HISTORIC CONSERVATION BOARD AGENDA

APPLICATION FOR CERTIFICATE OF APPROPRIATENESS HISTORIC CONSERVATION BOARD PUBLIC HEARING STAFF REPORT

APPLICATION #: COA2017031 APPLICANT: Sarah Cornell

OWNER: Storied Homes OTR, LLC ADDRESS: 1532 Republic Street 081-0004-0043-00

NEW WORK PLANS

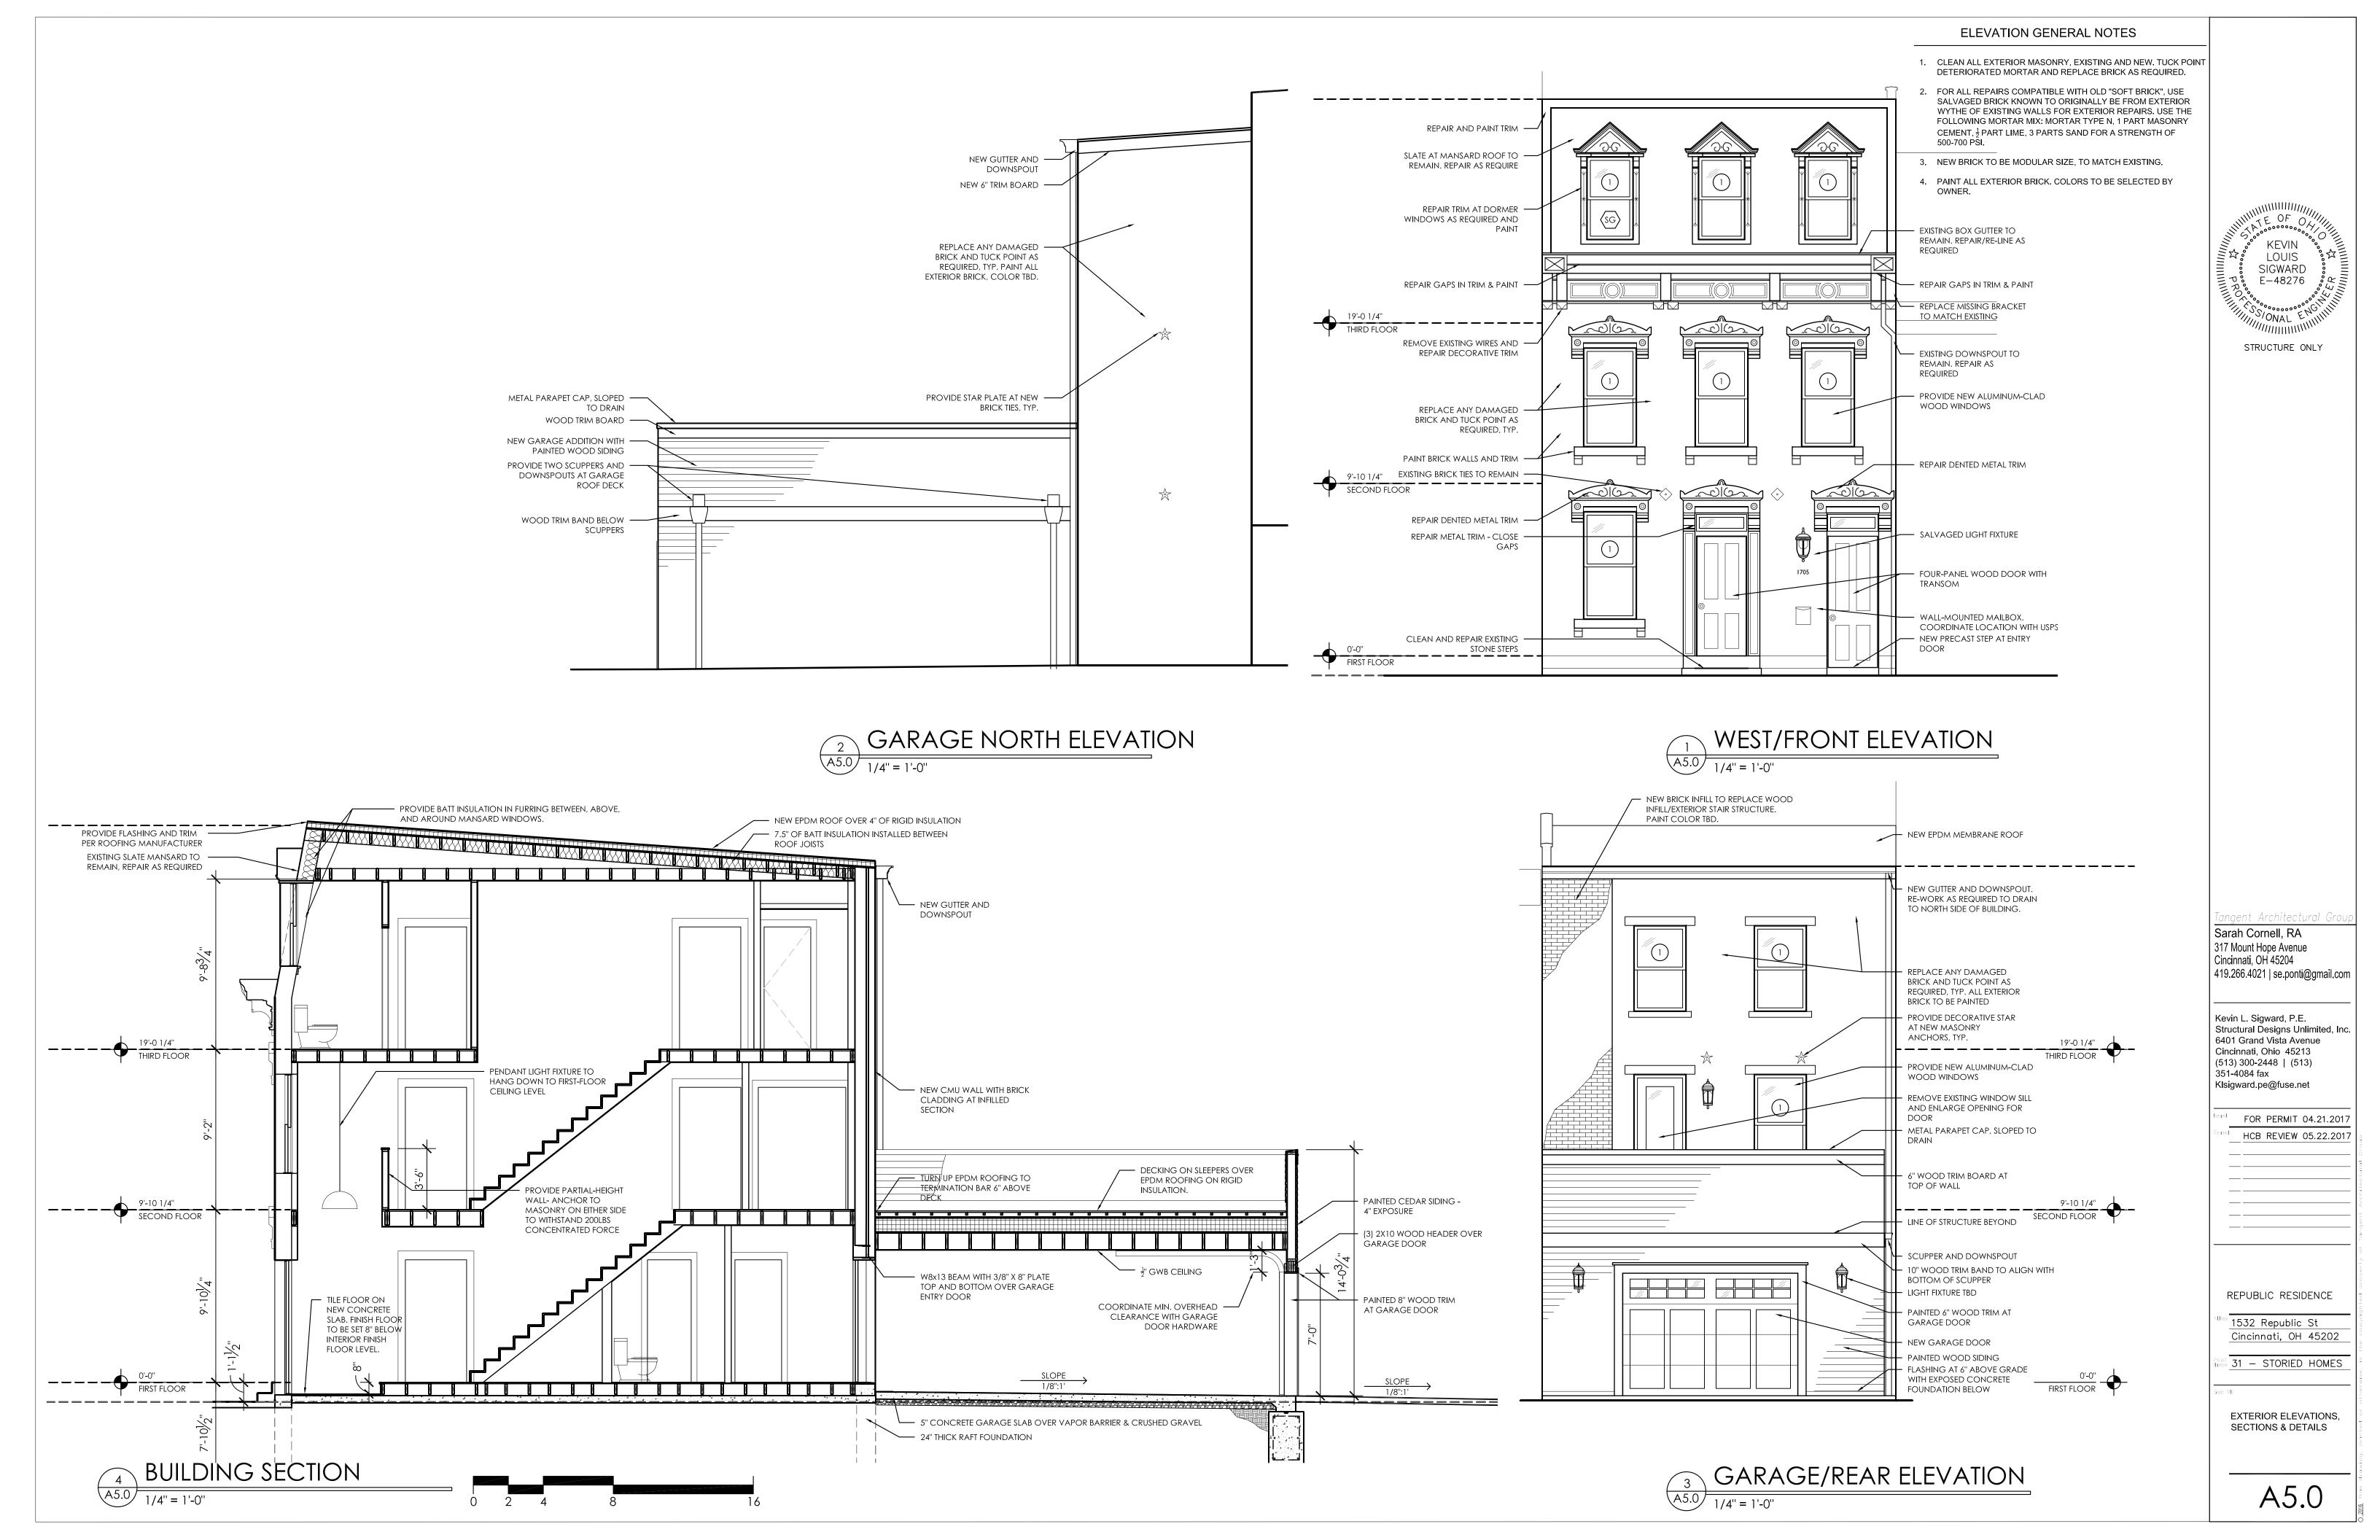
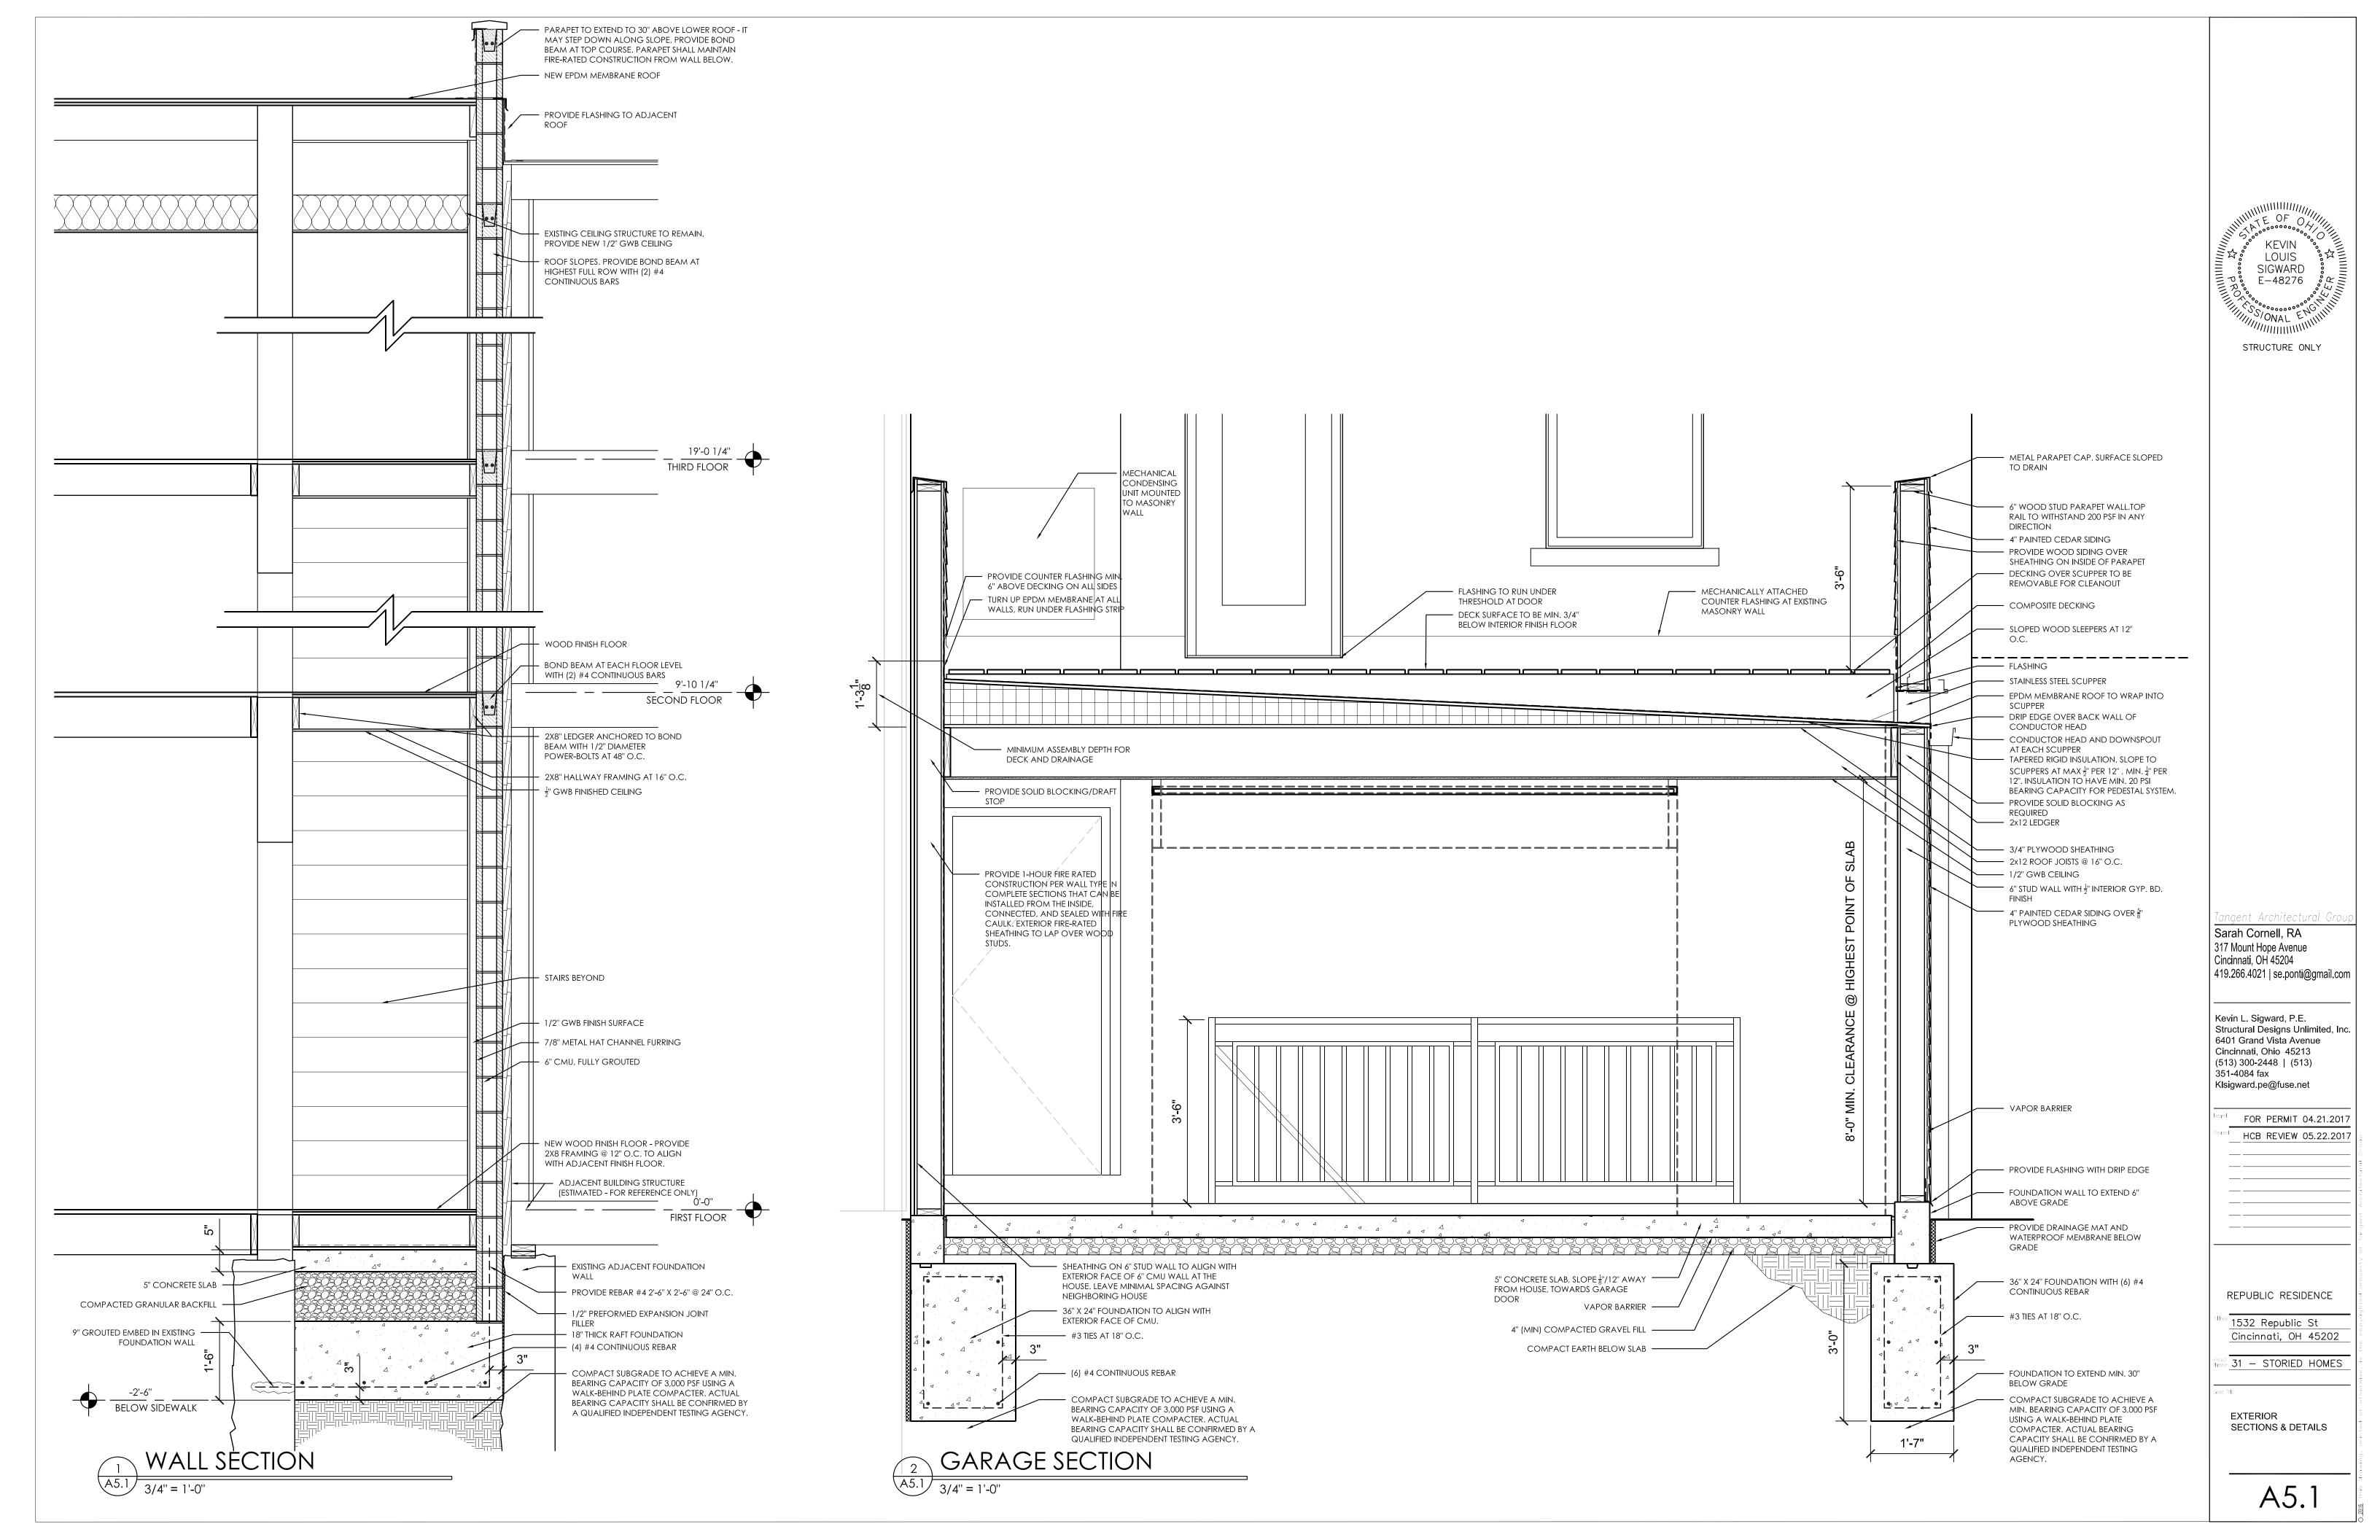
The rooftop deck proposed for the garage will not be visible from the principal façade fronting Republic Street, and will be minimally visible from the rear of the property, including E. Liberty Street. The deck will be screened by a brick parapet wall that will act as the railing. When viewed from the rear, the deck itself will not be visible. Access to the deck will be granted through a new doorway in an existing window opening on the second floor of the east elevation

- A.) APPROVE a Certificate of Appropriateness for 1532 Republic Street submitted by Sarah Cornell, dated 5/22/2017 including any revisions submitted for permit subject to staff review and approval with the following conditions.
 - a. The siding shall be between a 4-6" reveal
 - b. The building permits must be issued within two years of the decision date or the Certificate of Appropriateness shall expire.
- **B.) FINDING:** The Board makes this determination per Section 1435-09-2:
 - a. That the property owner has demonstrated by credible evidence that the proposal substantially conforms to the applicable conservation guidelines.
